1 INTRODUCTION

- 1.1.1 Velocity Transport Planning (VTP) has been appointed by Firethorn Trust (the Applicant) to provide highways and transport planning advice for an outline planning application relating to the development of up to 530 dwellings on land which forms part of the North West Bicester Eco Town development (Policy Bicester 1 of the adopted CDC Local Plan), located in Oxfordshire.
- 1.1.2 The Proposed Development description for the outline planning application, planning reference: 21/01630/OUT, is as follows:

- 2.2.1 VTP has prepared a standalone Technical Note 006 A4095 Interim Improvement, which addresses the concerns raised by OCC, and this Technical Note should be considered in association with this response. TN006 is included at **ATTACHMENT A**.
- 2.2.2 The summary and conclusions of TN006 are set out below for ease of reference:

TN006 – A4095 INTERIM IMPROVEMENT MITIGATION

Figure 3-1: Proposed Mini-roundabout General Arrangement

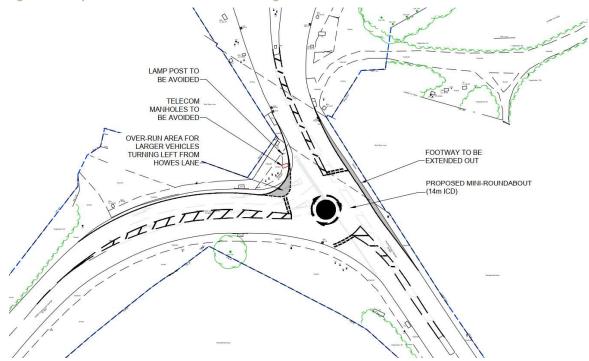
- **3.1.1** To mitigate the impact of the traffic associated with heb 530 dwellings of the Proposed Development at the junction and improve the operation of the existing A4095 Howes Lane / Bucknell Road priority junction, a mitigation scheme in the form of a proposed mini-roundabout arrangement has been developed.
- **3.1.2** The proposed mini-roundabout design has been developed in accordance with the requirements of the Design Manual for Roads and Bridges (DMRB) CD 116 Revision 2 'Geometric Design of Roundabouts'.
- **3.1.3** A plan showing the proposed arrangement of the mini-roundabout is included at **ATTACHMENT E**, and an extract of the General Arrangement is presented below in **Figure 3-1**.

Figure 3-2: Proposed Mini-roundabout Arrangement Swept Path Analysis

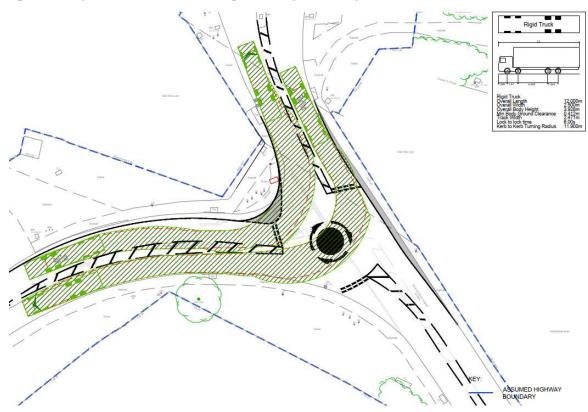
- 3.5.4 In addition, two 12m rigid vehicles can now pass simultaneously through the junction, as well as other HGVs and a car. An extract of this movement is included in Figure 3-2, and a full copy is provided at ATTACHMENT E.

- **3.5.5** The proposed mitigation scheme, therefore, provides operational improvements from the existing arrangement by allowing easier movement of vehicles, particularly HGVs, through the junction without incursion into the opposing lanes.

Project Title						
NW BICESTER						
Drawing Title						
A4095 HOWES LANE/ BUCKNELL ROAD						
PROPOSED JUNCTION						
GENERAL ARRANGEMENT						
Scale @ A3	Date	Designed/Drawn	Checked	Approved		
1:500	01/03/22	GSF	CR	M١	<	
Project Ref	Drawing Numbe	Rev				
4600-1100	00-1100 4600-1100-T-054

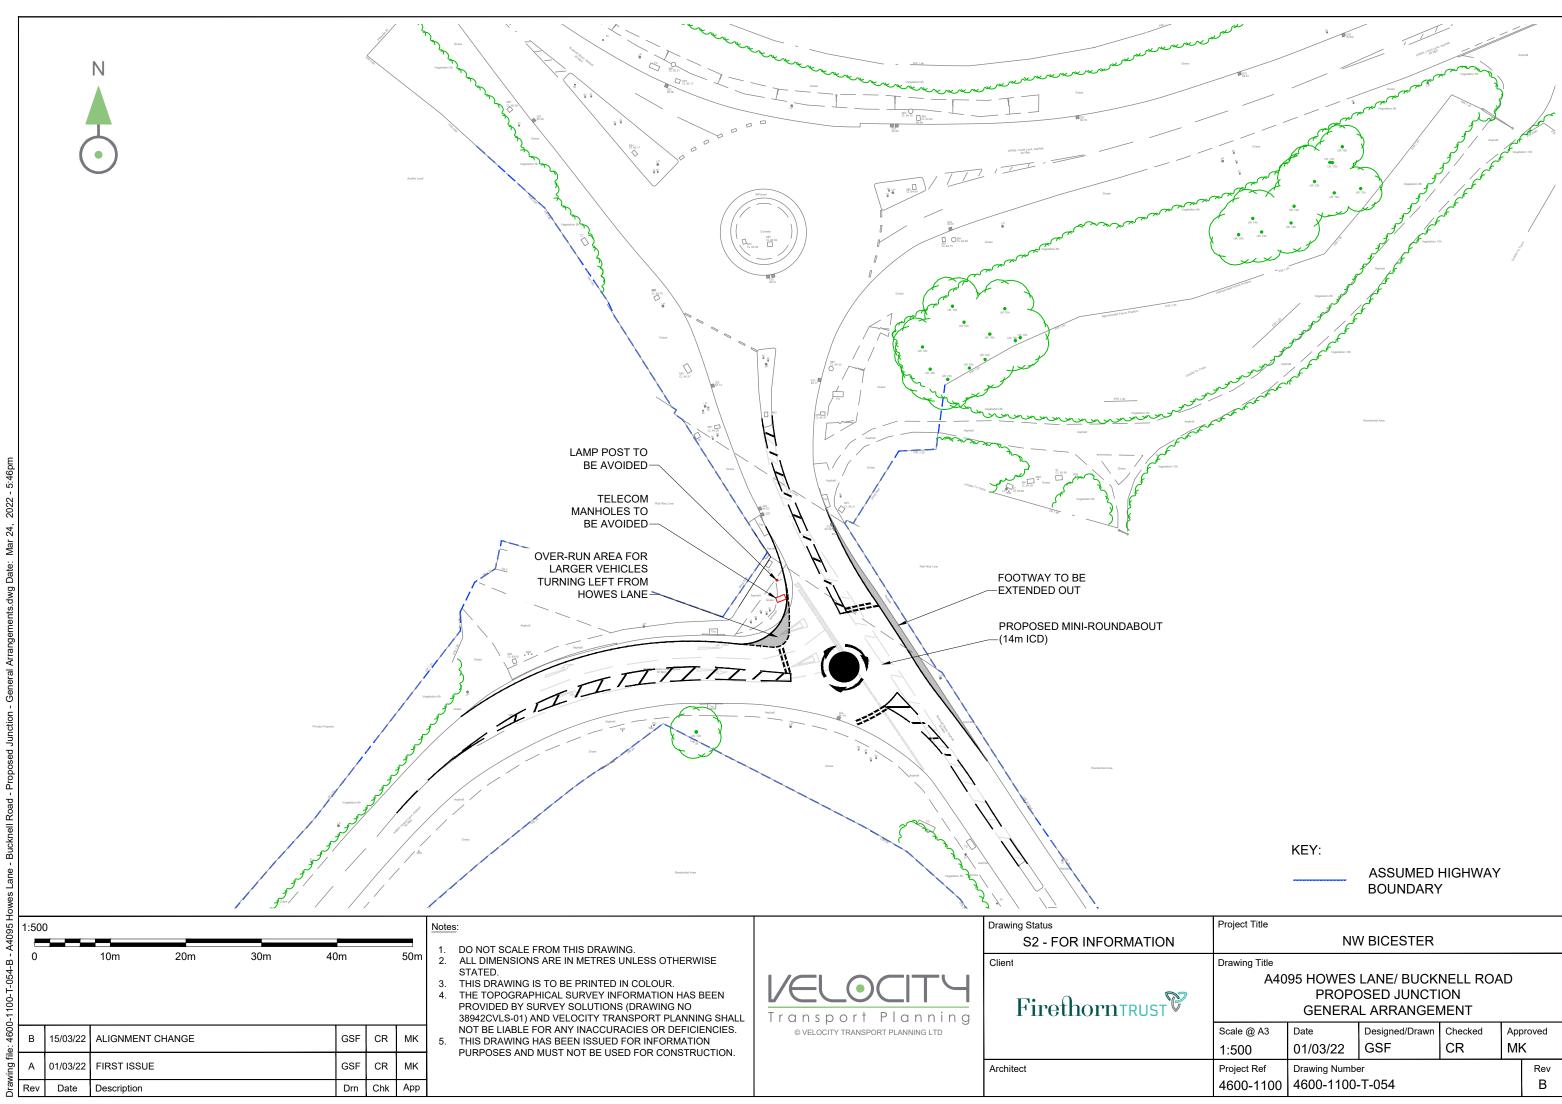
- **4.3.3** The general arrangement of the proposed mini-roundabout is presented on the VTP drawing included at **ATTACHMENT E** and offers the following improvements from the existing priority junction arrangement:
